Topic: Thermal cut-out update		TB No.: TB10057	Date: 10/06/2022
Affected Machines:	All Eco boiler/ Ecosmart range	Priority: Low	Created By: Eddie Purtil
From Serial No.:	>03/20	Created For:	Technicians
From Date:	March 2020	Pages: 1/1

UPDATE

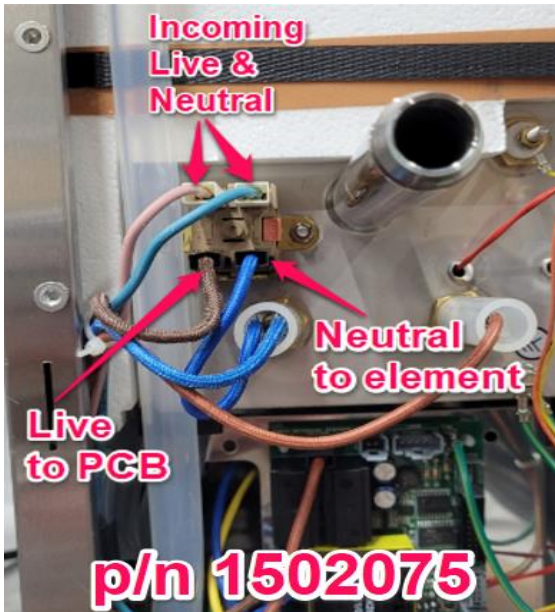
A new Double pole overheat is being fitted to Eco boiler after serial no 0320XXXX.

***** The two versions of overheats will not be interchangeable. *** Must exchange like for like!**

The new overheat (1502075) will be fitted to the incoming live and neutral of the flex and when it trips it will cut the power to the boiler, not just the element like the older version (1502087). This will mean that when it trips all the lights on display will go out and the error for not heating (4 flashes) will not be displayed.

PART CODES

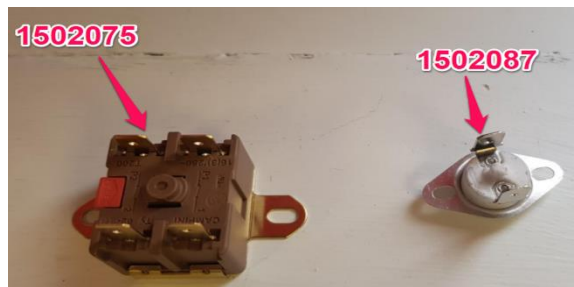
Thermal Switch Dual Pole 125deg part no 1502075

Thermal Switch 130 deg part no 1502087.
